Whitehorse City Council submission

Urban Design and Landscape Plan

North East Link

Eastern Freeway Upgrades – Burke Road to Tram Road

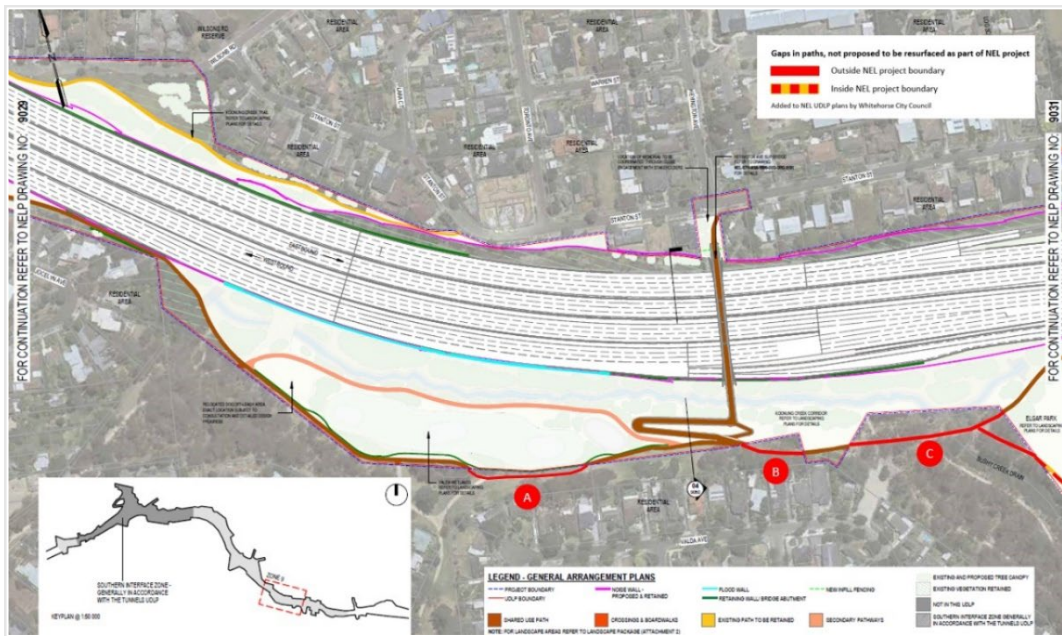
50. SUPs outside of the project boundary, even where skirting its edge, are not identified for upgrade. The subsequent ‘stitching’ of paths of mixed widths, condition, quality, materiality and colour is not considered to be an integrated, continuous or seamless outcome but rather one that represents a piecemeal approach. It is not consistent with providing infrastructure that meets universal design standards to accommodate the use and accessibility for people with limited mobility or with sensory impairments.

Upgrading of the entire Koonung Creek Trail is required to avoid the safety and aesthetic problems associated with mixing width, quality, condition and materiality of path surfaces.

NEL Eastern Freeway Upgrades ULDP Attachment 1, Architecture and Urban Design Part 1, Zone 9.

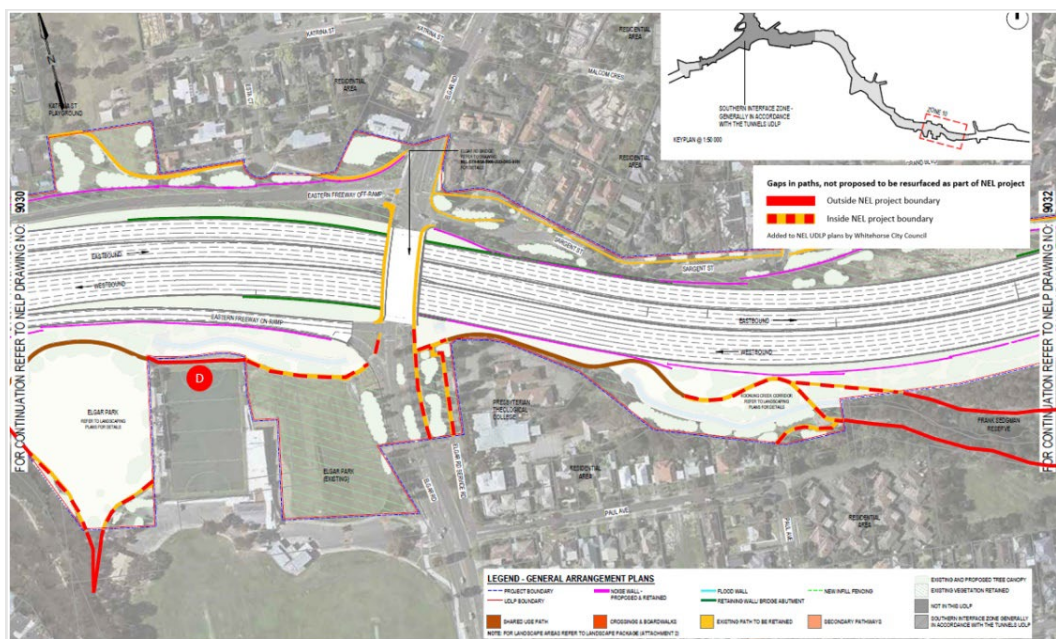
53. Obvious locations where this will occur within the City of Whitehorse include (but are not limited to):
- Southern edge of Valda Wetlands.
 - A short gap between realigned SUP to the immediate east of the new Heyington Avenue bridge ramping.
 - A further gap between the Heyington Avenue bridge and Elgar Park.
 - Gap between realigned SUP and 'existing path to be retained' narrowly skirting the project boundary to the northern edge of the Elgar Park hockey pitch.

These locations are marked on the following maps in red.

NEL Eastern Freeway Upgrades ULDP Attachment 1, Architecture and Urban Design Part 1, Zone 9 and 10

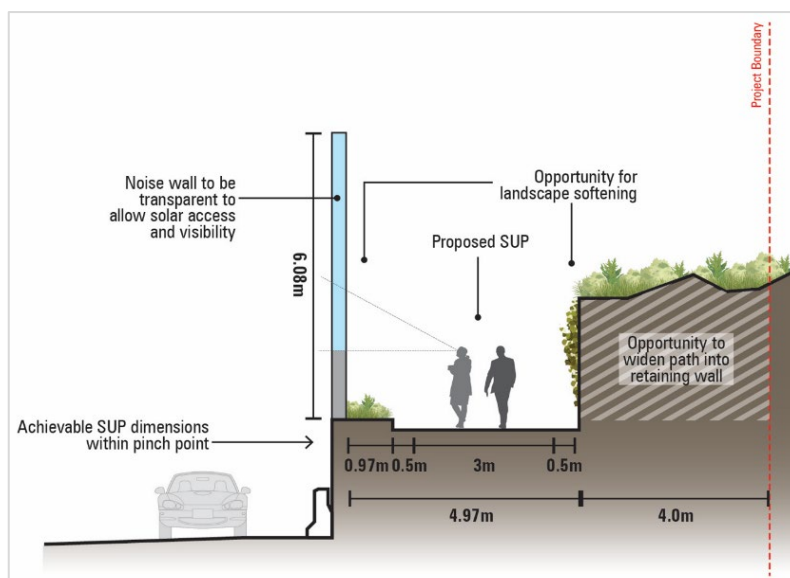
68. Pinch points caused by the narrow openings between proposed noise walls and the adjoining private or public realm along the SUP network are identified at:

- a) Between the rear of Jocelyn Avenue properties and the Eastern Freeway corridor.
- b) Between the Koonung Creek and the northern edge of the Elgar Park hockey pitch.
- c) Between the freeway corridor and 690 Elgar Road (east of Elgar Road).

69. The Jocelyn Avenue pinch point appears to present the narrowest trail cross section along the whole UDLF alignment. The lack of dimensions in the UDLF however make it difficult to review this pinch point. Measuring to scale, from Attachment 2, Drawing 9559, the cross section appears less than 5m between the proposed noise wall and existing retaining wall. The noise wall is measured at 6m in height from the SUP pavement (8m in height from the freeway pavement).

Encroachment of Eastern Freeway into open space, based on NELP Drawing No. 9544

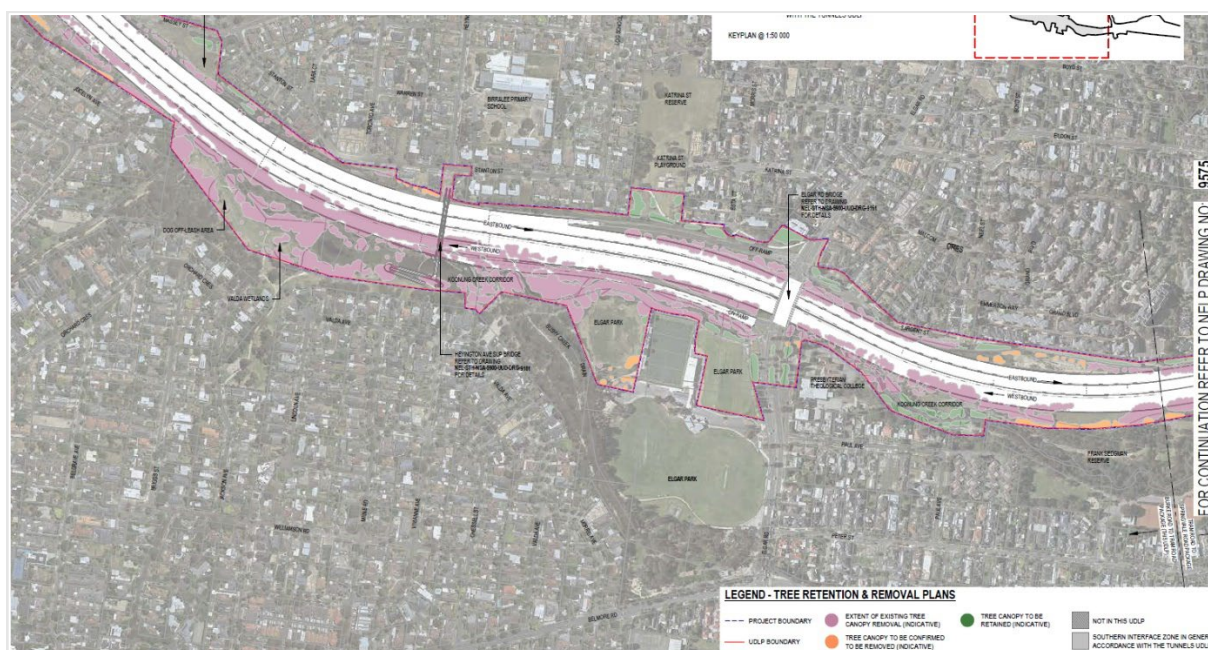
89. Council has measured the encroachment of the freeway south into the open space (based on NELP's Landscape Drawing No. 9544) as approximately 15,000m². This is based on the calculation of land between the existing noise wall or fencing, and proposed noise/flood walls.
90. The following assumptions were made in producing these calculations:
- The 'existing freeway interface' was mapped as existing fencing and/or noise walls – whichever was closer to accessible open space.
 - The 'proposed freeway interface' was mapped as the proposed noise/flood walls illustrated on the landscape plans.
 - The degree of encroachment was measured as the difference between the 'existing freeway interface' and 'proposed freeway interface.'

Eastern Freeway Upgrades Burke Road to Tram Road UDLP - Tree retention and removal plan – Zone C

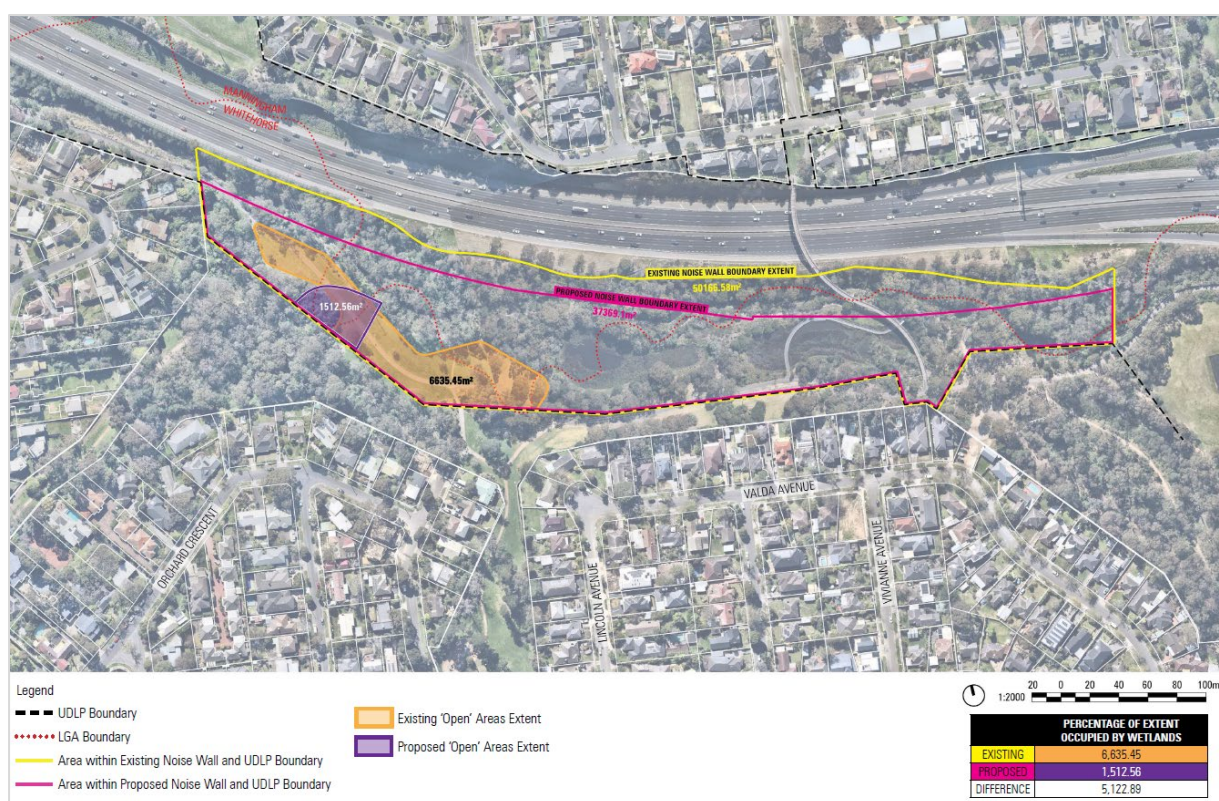
91. The Tree Retention and Removal Plans for the project extent within Whitehorse illustrate that almost all tree canopy within the project boundary is being removed (pink on the plan below) with only small patches of retention (green).

Encroachment of Eastern Freeway into open space, based on NELP Drawing No. 9545

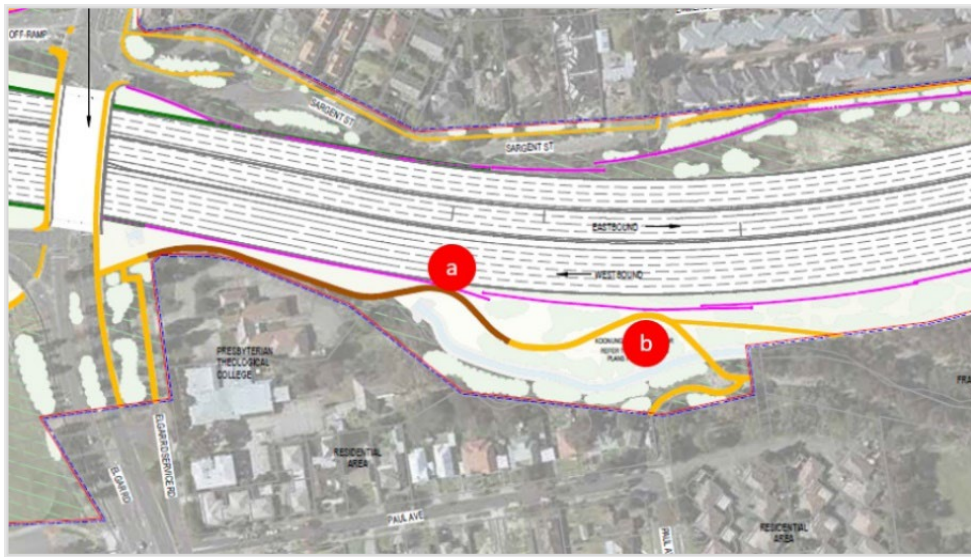
127. The southern encroachment of the freeway at Elgar Park’s northern interface is generally of less impact than near Valda Wetlands. Additional traffic lanes at this location are mostly confined within the freeway corridor and absorb space currently serving as landscaped embankments.

Encroachment of Eastern Freeway into open space, based on NELP Drawing No. 9546

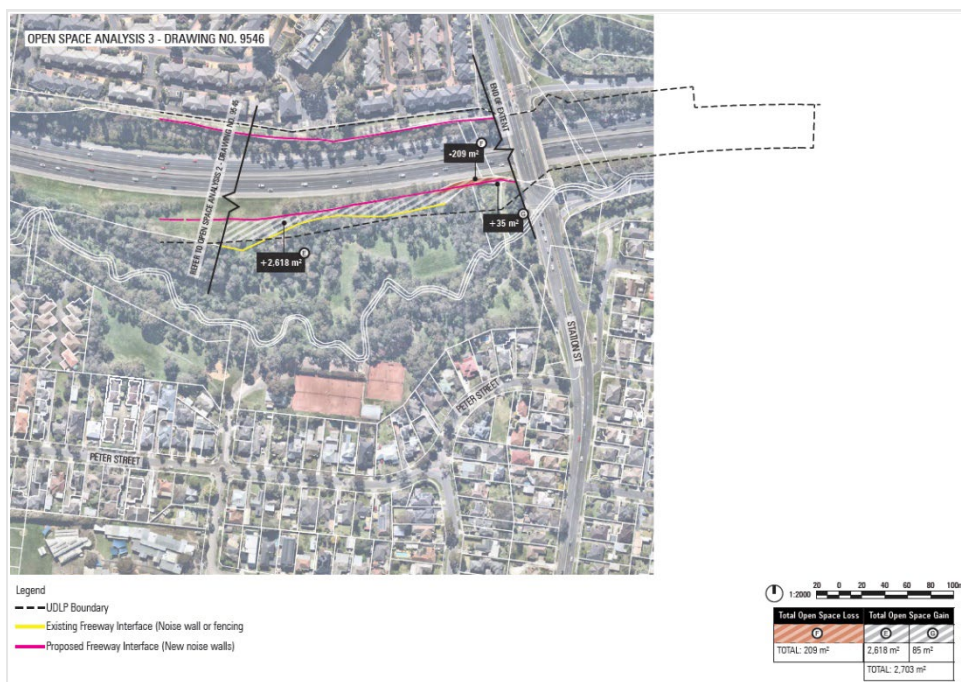
138. The southern encroachment of the freeway at Frank Sedgman Reserve is limited to land to the north of the creek alignment as illustrated below.
